Zlin Aviation S.R.O.

Safety Alert	Nº01	13 December 2006
---------------------	-------------	-------------------------

- **Airplanes affected:**
all Savage Aircrafts and models
- **Subject:**
New cables and Pulleys for Vertical Tail
- **Reason:**

Picture 1: steel bushing to be cutted

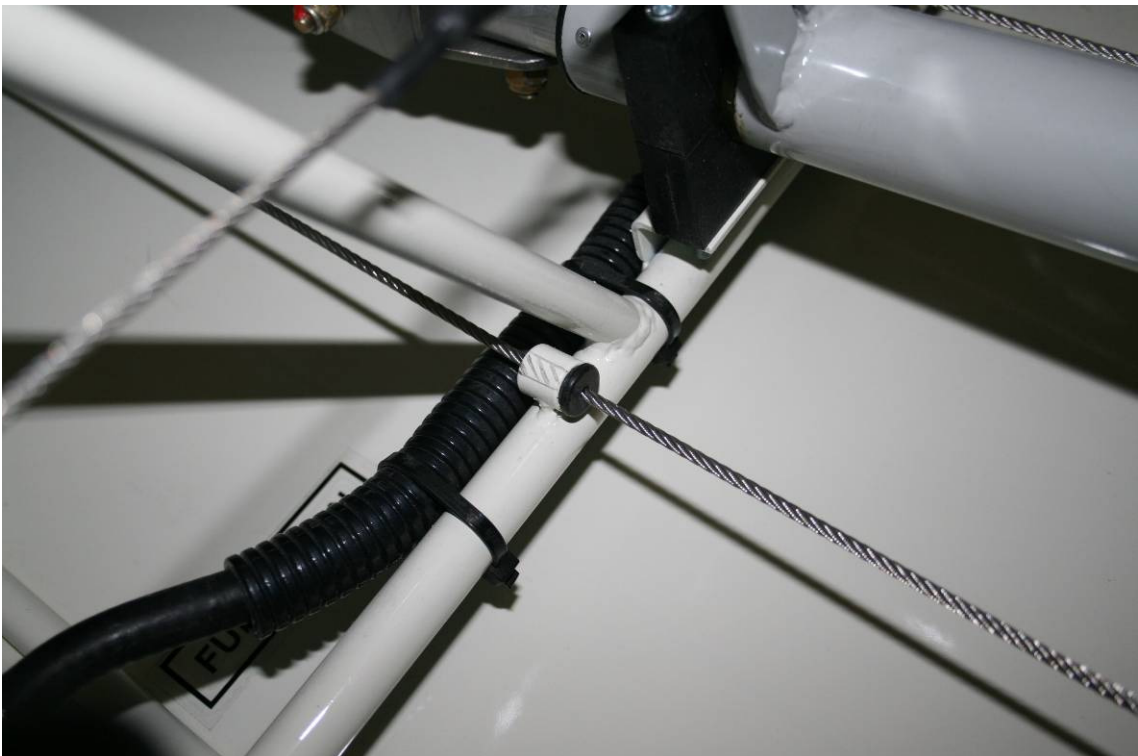
To ensure the assembling of the new two cables and their plastic bushings into the frame of the fuselage (see the pictures) it is necessary to cut the small steel tube on the bottom of the fuselage behind the rear seat, two times about 3,2 mm apart, stretch out a little and insert the bushing and draw back. A visual control of the alignment of the cables with the pulleys *has to be made*. It is possible to correct the alignment eventually screwing the steel plate of the cable, inside the rear pedals and not outside like usually is done. Bending “*just*” a little this steel plate is also an alternative.
